**Re: STB Docket No. FD 34284—Southwest Gulf Railroad Company—
Construction and Operation Exemption—In Medina County, Texas; no
historic properties affected determination for three archaeological sites and
project update on architectural properties**

**Southwest Gulf Railroad Company Construction and
Operation of the Proposed Single-Track Railroad
Resolution Plan Status: April 19, 2018.**

**Southwest Gulf Railroad Company Construction and
Operation of the Proposed Single-Track Railroad
Resolution Plan: Vegetative Buffers.**

Comments on the Revised Draft Report: *Phase II Testing of Sites 41ME260, 41ME261 and 41ME264 for the Southwest Gulf Railroad Company Construction and Operation of the Proposed Single-Track Railroad, Medina County, Texas* (STB).

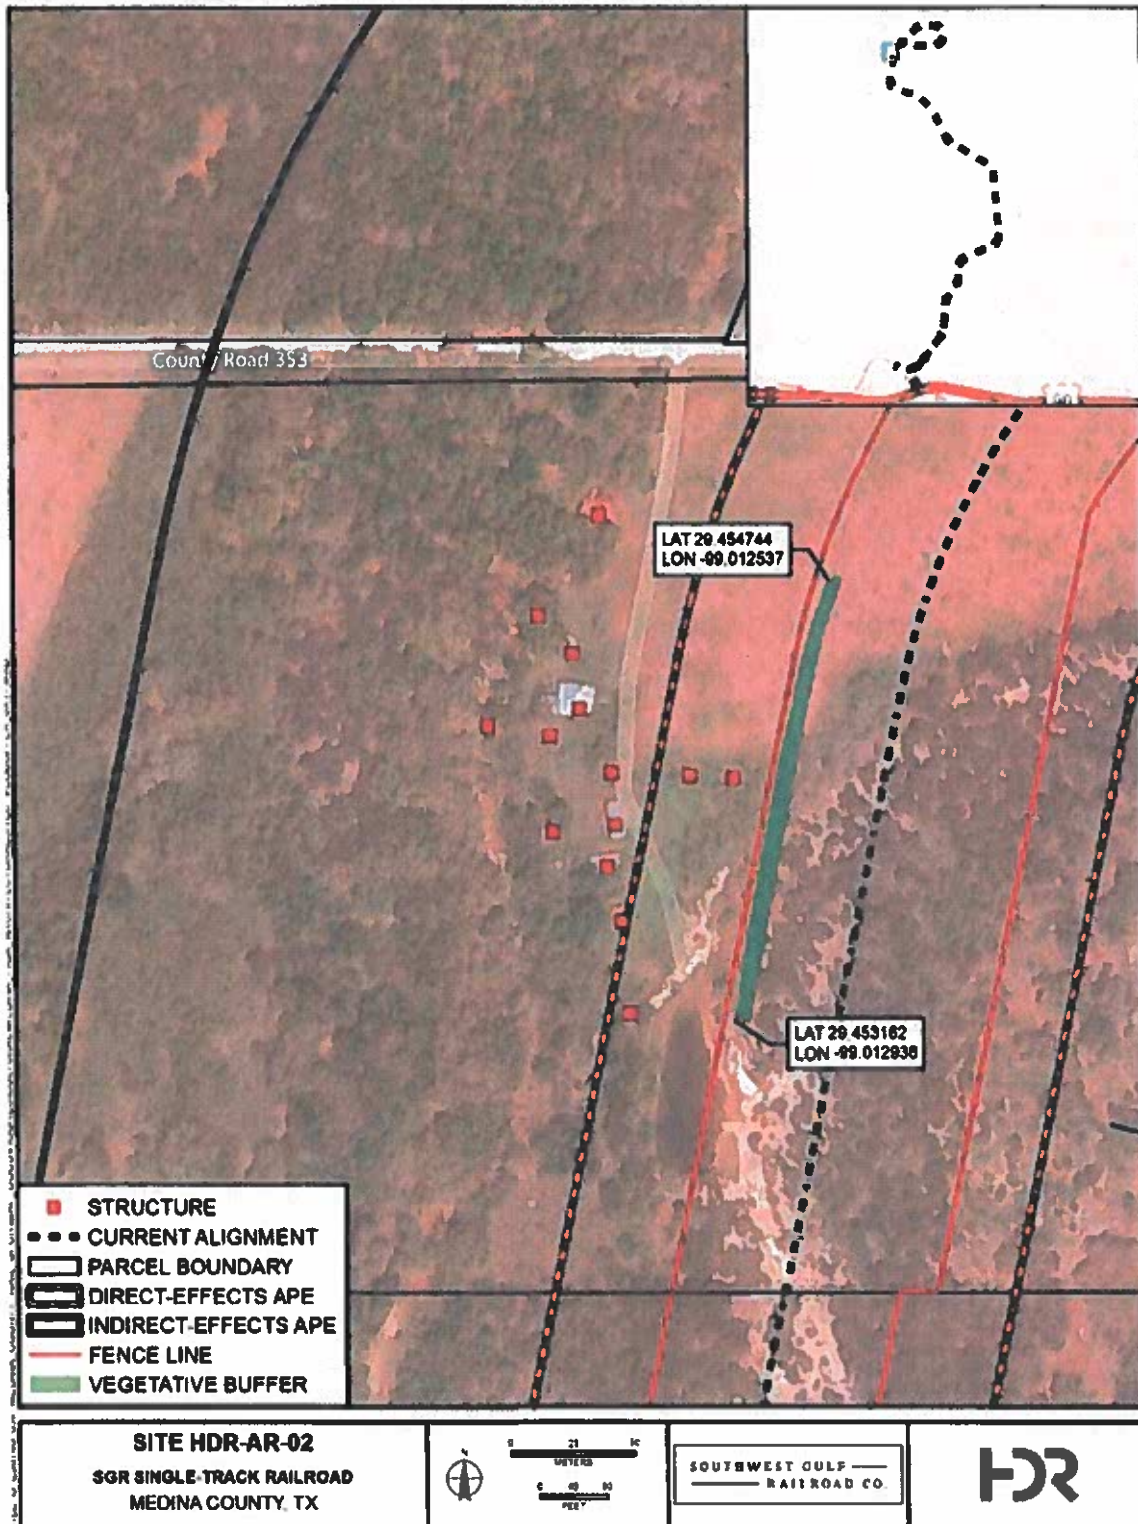
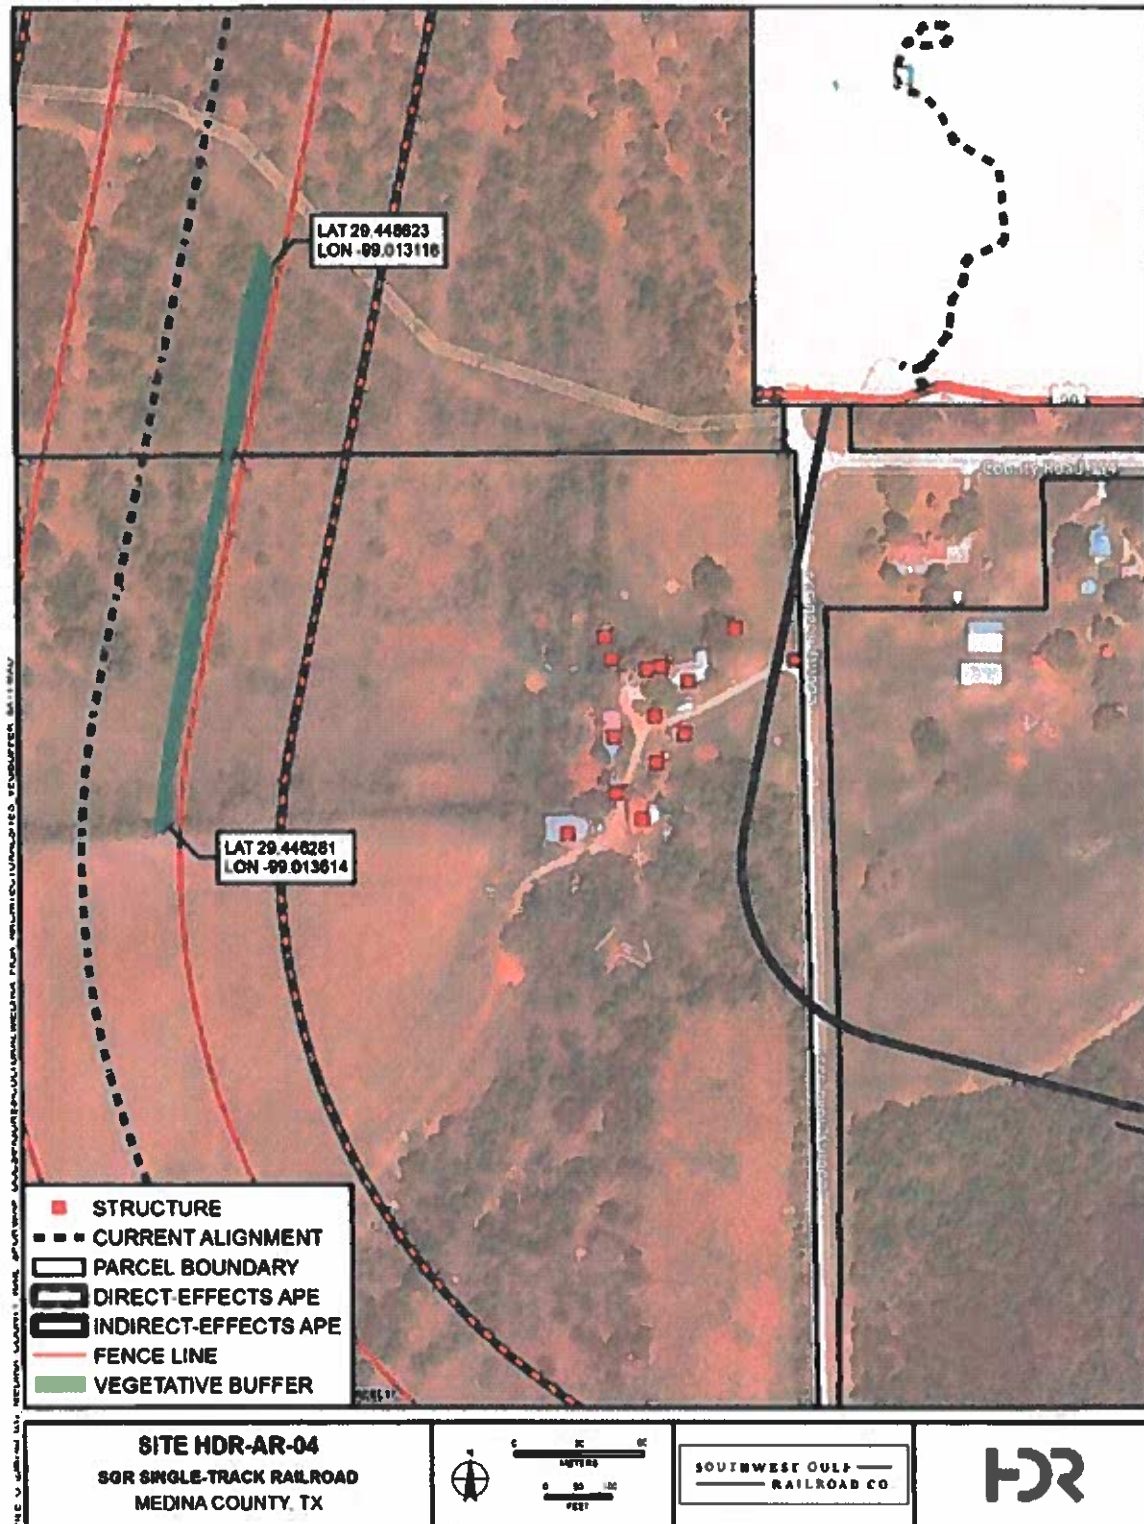
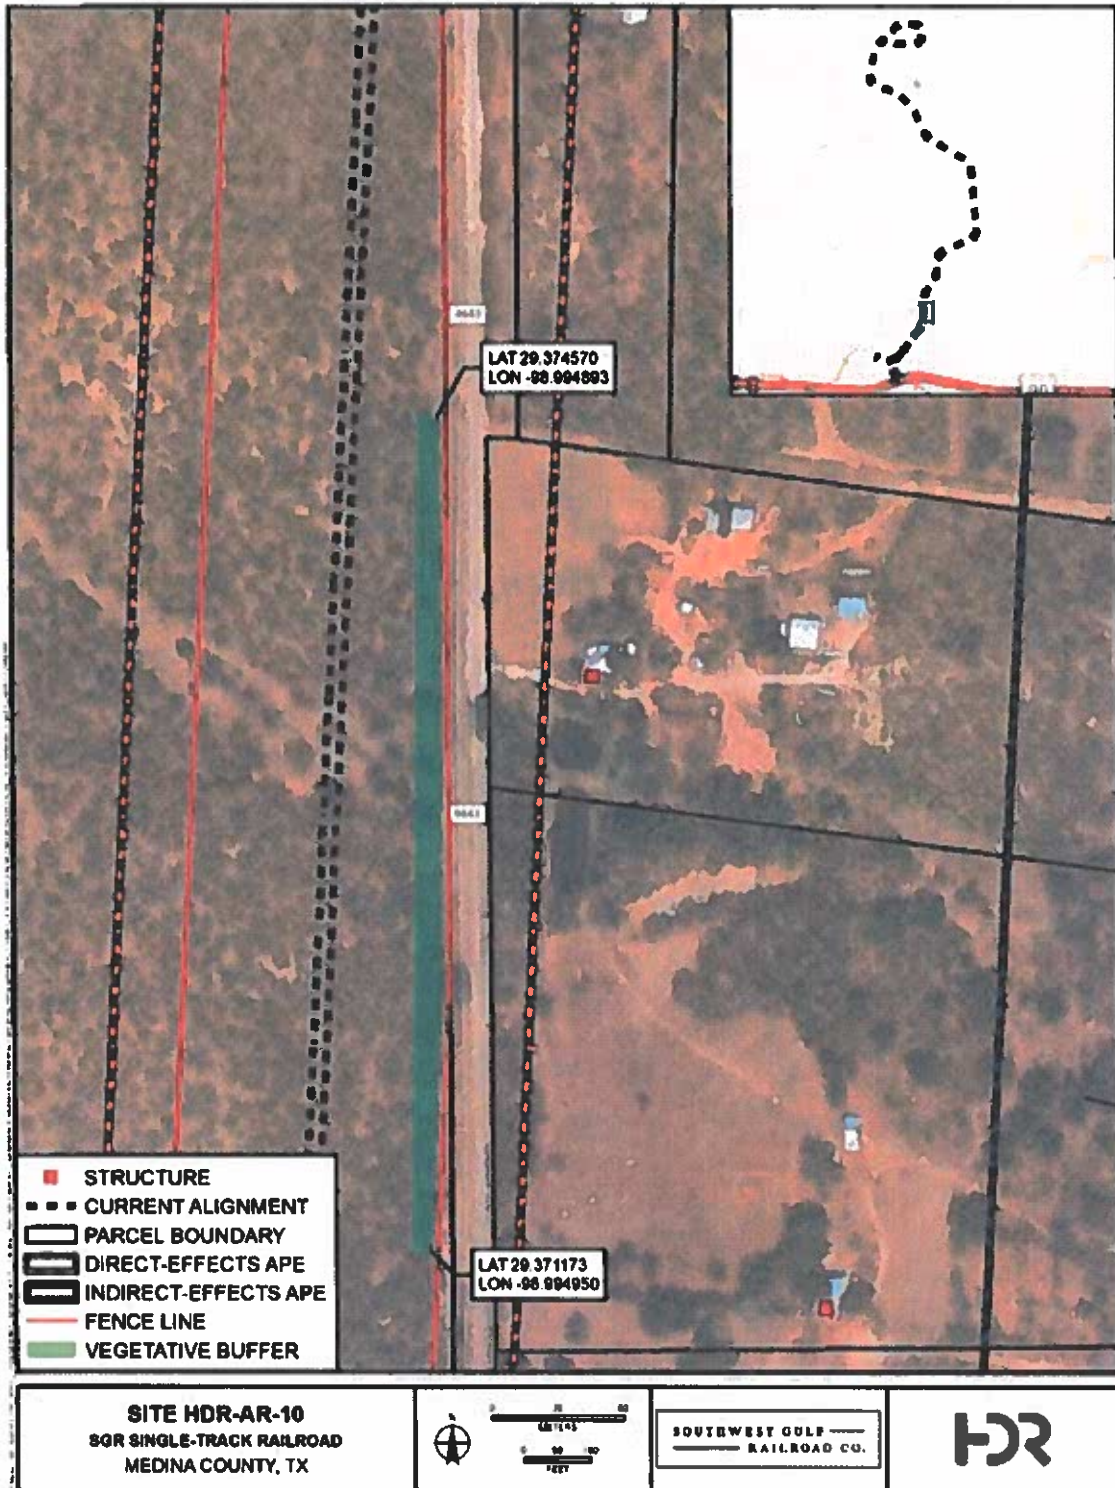
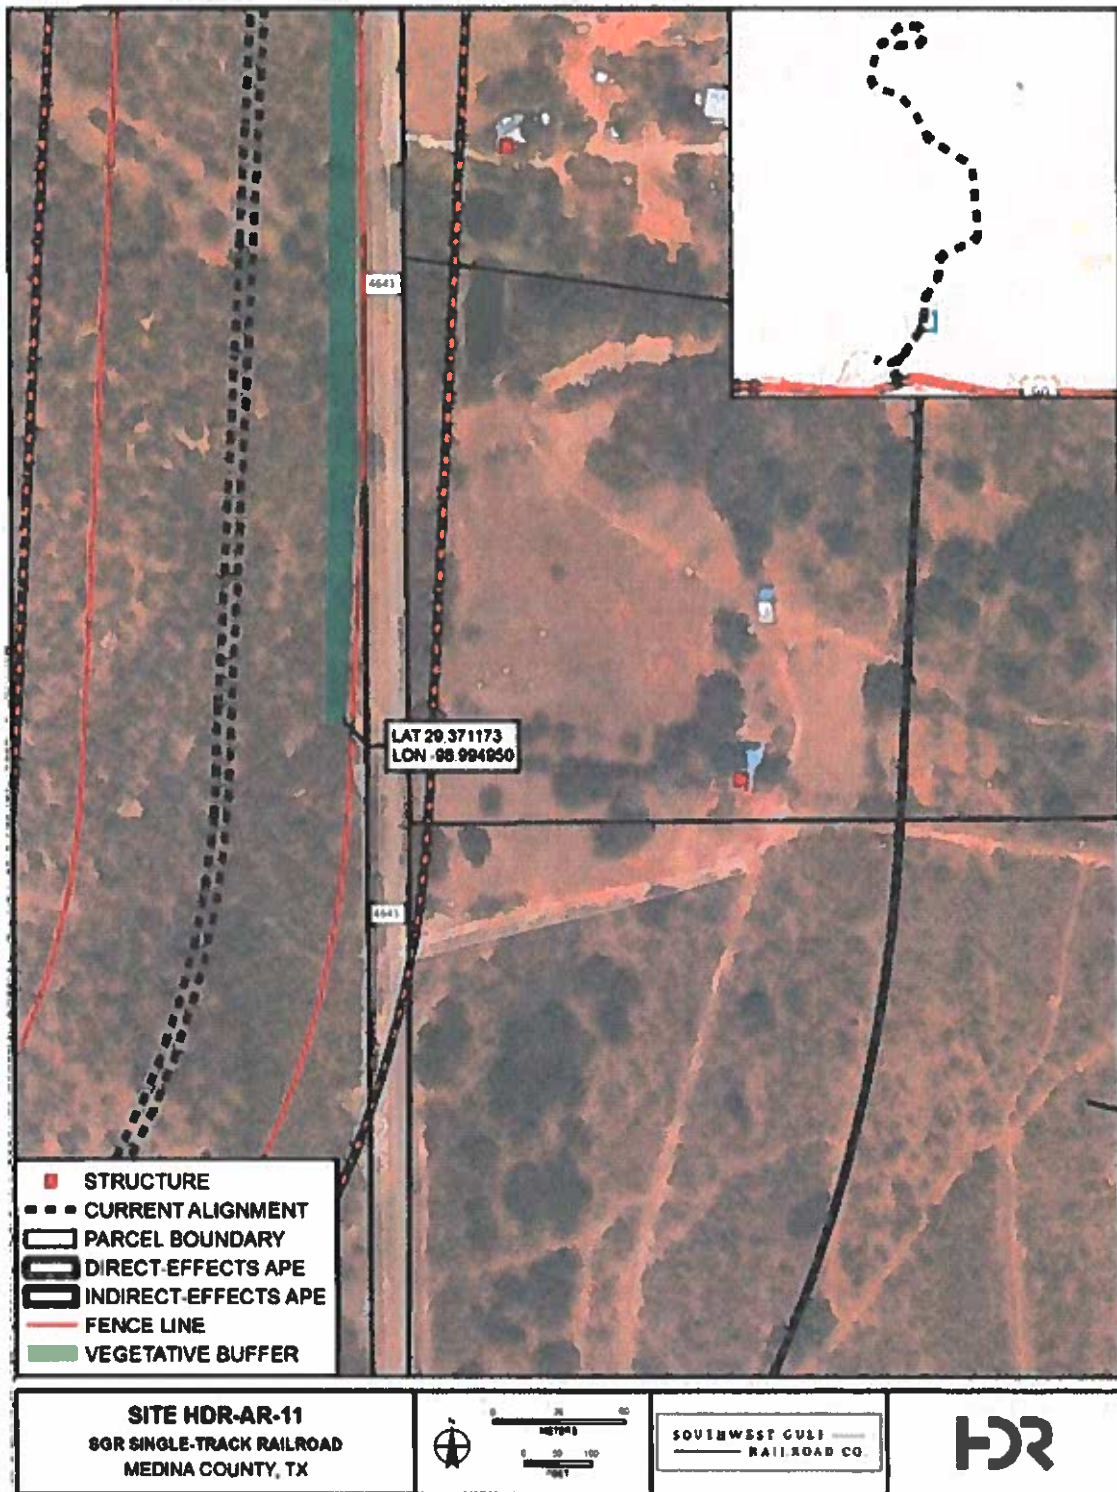
The review staff, led by Casey Hanson, Justin Kockritz and Sara Ludueña, has completed its review of the information regarding the required mitigation agreed to by the parties involved in this undertaking as well as the schematic proposed vegetative buffer. We appreciate you providing an update on the status of the various mitigation measures and we look forward to reviewing the exhibit and educational materials when a draft is complete. In terms of the vegetative buffer, we agree that the approach of planting two staggered rows of low trees is appropriate, and the species described will create a sufficient visual buffer between the historic resources and the rail line.
